Serial No. 06-140E
KPS/LIC/CDS: R6
Docket No. 50-305
License No. DPR-43

DOMINION ENERGY KEWAUNEE, INC.
KEWAUNEE POWER STATION
RESPONSE TO NRC SUPPLEMENTAL QUESTIONS REGARDING LICENSE
AMENDMENT REQUEST 215, "MODIFICATION OF INTERNAL FLOODING DESIGN
BASIS"

**RESPONSE TO NRC SUPPLEMENTAL QUESTIONS REGARDING
KEWAUNEE LICENSE AMENDMENT REQUEST 215
“MODIFICATION OF INTERNAL FLOODING DESIGN BASIS”**

SIMPLIFIED DRAWING OF SERVICE WATER PIPING IN THE AREA OF THE EMERGENCY DIESEL GENERATOR ROOMS

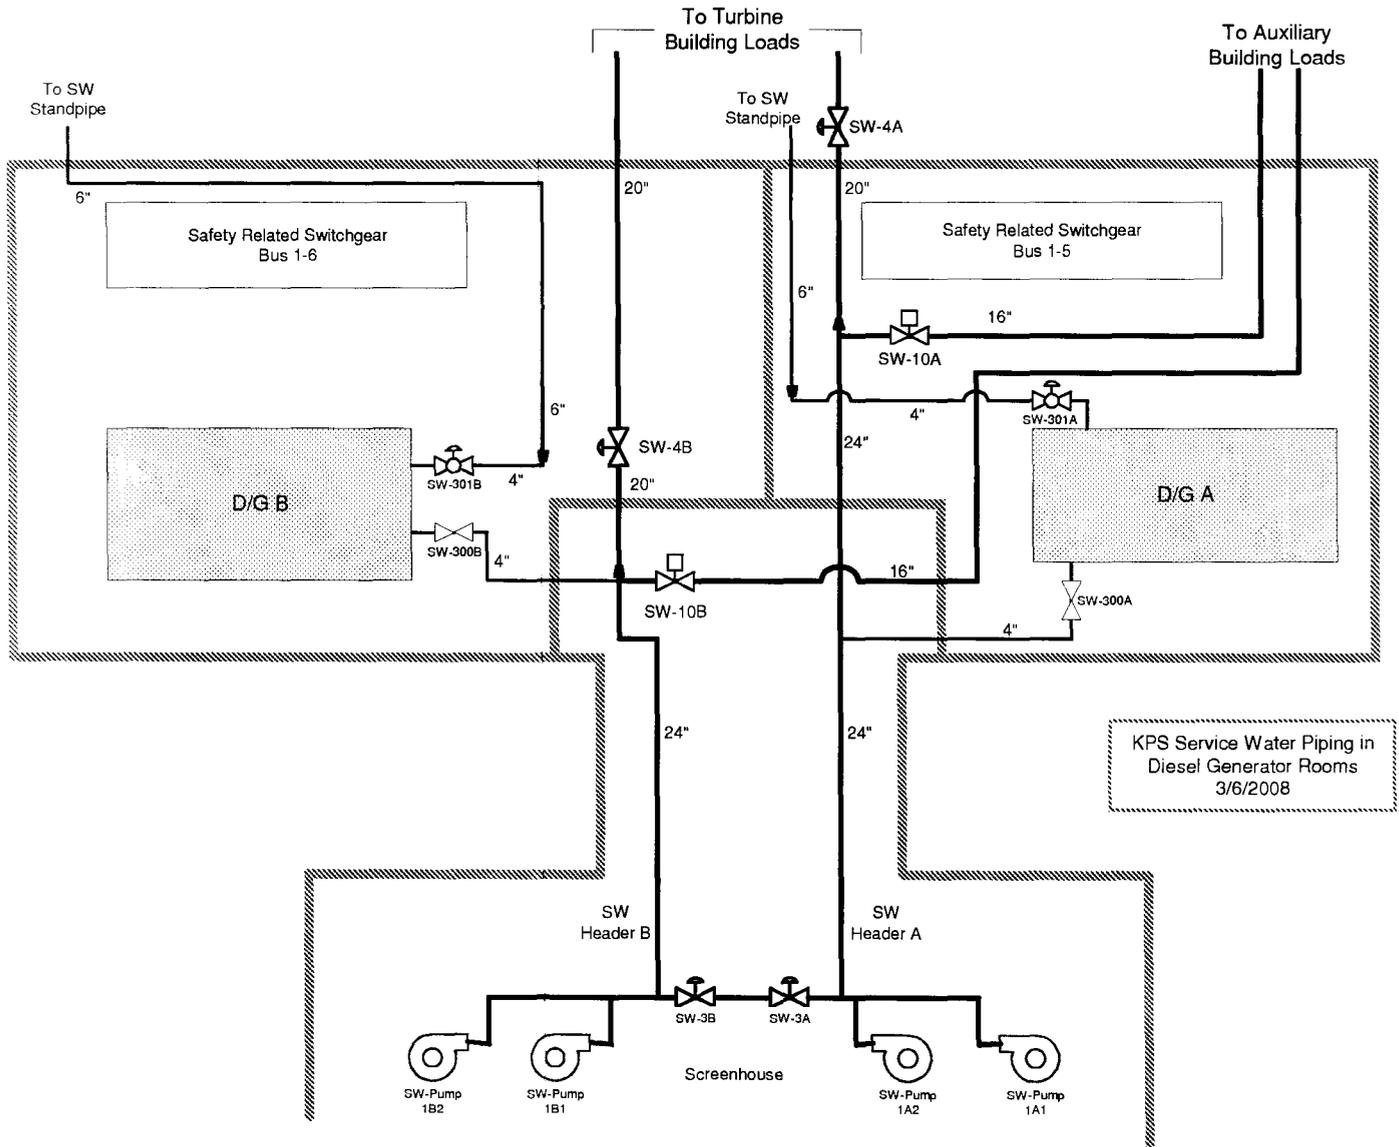
“Figure 1.2-1 of the FSAR shows service water lines either running through or in the immediate vicinity of the emergency diesel generator rooms. Provide an analysis of the effect of a rupture of one of these service water lines on the emergency power systems.”

In the A EDG room, there are A train service water lines of 24, 20, 16, 6, and 4 inches and a B train service water line of 16 inches. In the B EDG room there are B train service water lines of 20, 6, and 4 inches. In the case where a B service water line ruptured in the B EDG room or the A service water line ruptured in the A EDG room, splitting the main service water headers with valves SW-3A or SW-3B and turning off the service water pumps for the affected train would stop the leak and leave the unaffected service water train fully OPERABLE.

“The rupture of a service water line in an Emergency Diesel Generator Room could result in the loss of the generator or the safeguards bus in that room. Administrative operation from the Control Room of Type I Service Water valving would isolate the break and, if required, realign the Service Water supplies through the intact piping from the operating Service Water Pumps.”

As stated in the response from 1971 above, "Administrative operation from the control room of Type I Service Water valving would isolate the break..." This would be accomplished by closure of the appropriate Auxiliary Building service water header isolation valve (SW-10A or SW-10B) or the main service water header isolation valve (SW-3A or SW-3B) per procedure OP-KW-AOP-SW-001, "Abnormal Service Water System Operation." The service water lines to the EDG cooling water heat exchangers branch off upstream of SW-10A or SW-10B. Therefore, service water to the associated EDG would not be isolated if the hypothetical break occurred. Subsequent isolation of an Auxiliary Building service water header using SW-10A or SW-10B would render all equipment in the Auxiliary Building and safeguards alley for the train that relies on the isolated service water supply INOPERABLE.

With service water flow available to both EDGs, "the effect of a rupture of one of these service water lines on the emergency power systems" is limited to the direct effect discussed above. Closure of the SW-10A or SW-10B valve would isolate the auxiliary building service water supply to the respective train of equipment. Realignment of service water through intact piping by opening the service water main header isolation valves (SW-3A and SW-3B) could be accomplished if necessary.

Realignment of the service water supplies through the opposite train piping can be accomplished by opening service water header isolation valves, SW-3A and SW-3B. (Note: SW-3A and SW-3B are normally open, but isolate on low service water pressure to separate the service water system into two independent trains.) In the event of a catastrophic failure of a service water line in an EDG room, SW-3A and SW-3B would automatically close, isolating train A and train B portions of the main service water header from each other. The flood water would cause the safeguards bus in the associated EDG room to trip.
